3/4.3.2 SAFETY SYSTEM INSTRUMENTATION

DAVIS-BESSE, UNIT 1

DocId Number 50-346
License Number NPP-3
Serial Number 2051
Attachment
Page 11

Insert for Table 3.3-3, Notation '*****'

INDEX

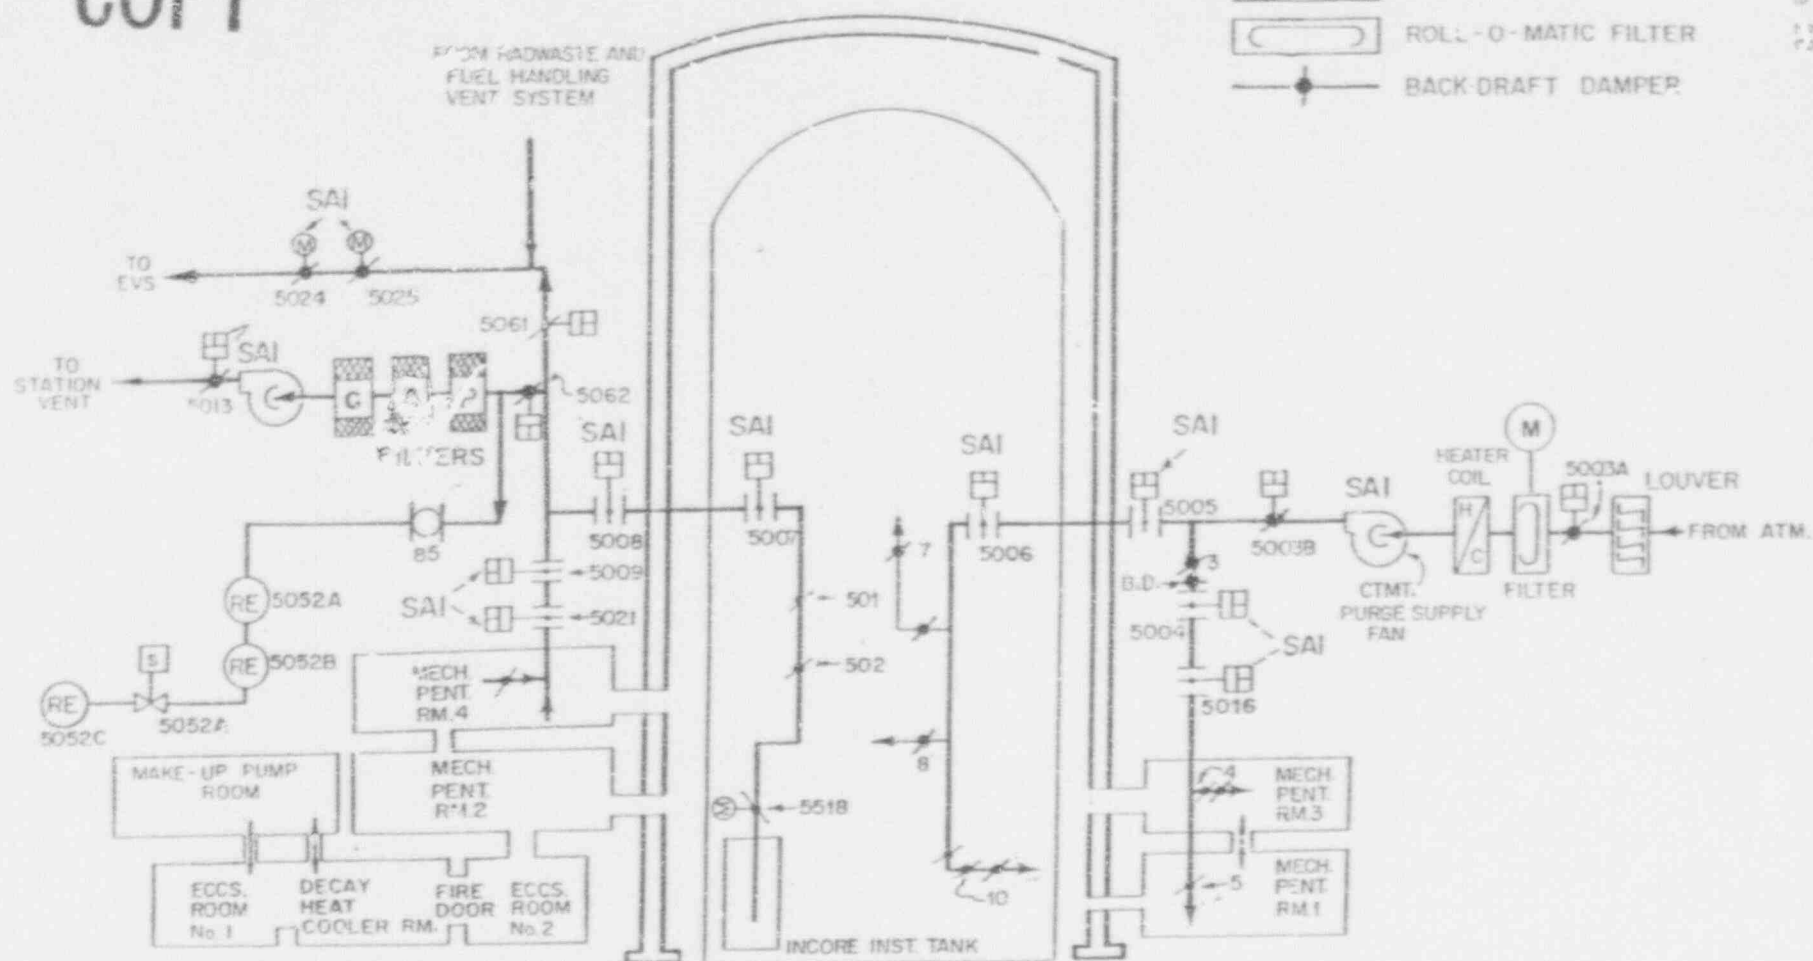
<u>SECTION</u>	<u>PAGE</u>
3/4.9.6 FUEL HANDLING BRIDGE OPERABILITY.....	B 3/4 9-2
3/4.9.7 CRANE TRAVEL - FUEL HANDLING BUILDING.....	B 3/4 9-2
DELETED 3/4.9.8 COOLANT CIRCULATION.....	B 3/4 9-2
3/4.9.9 <u>CONTAINMENT PURGE AND EXHAUST ISOLATION SYSTEM.</u>	B 3/4 9-2
3/4.9.10 and 3/4.9.11 WATER LEVEL - REACTOR VESSEL AND STORAGE POOL.....	B 3/4 9-2 ①
3/4.9.12 STORAGE POOL VENTILATION.....	B 3/4 9-3
3/4.9.13 SPENT FUEL POOL FUEL ASSEMBLY STORAGE.....	B 3/4 9-3
<u>3/4.10 SPECIAL TEST EXCEPTIONS</u>	
3/4.10.1 GROUP HEIGHT, INSERTION AND POWER DISTRIBUTION LIMITS.....	B 3/4 10-1
3/4.10.2 PHYSICS TESTS.....	B 3/4 10-1
3/4.10.3 REACTOR COOLANT LOOPS.....	B 3/4 10-1
3/4.10.4 SHUTDOWN MARGIN.....	B 3/4 10-1
<u>3/4.11 RADIOACTIVE EFFLUENTS</u>	
3/4.11.1 LIQUID EFFLUENTS	B 3/4 11-1
3/4.11.2 GASEOUS EFFLUENTS.....	B 3/4 11-3
3/4.11.3 SOLID RADIOACTIVE WASTE.....	B 3/4 11-6
3/4.11.4 TOTAL DOSE.....	B 3/4 11-7
<u>3/4.12 RADIOLOGICAL ENVIRONMENTAL MONITORING</u>
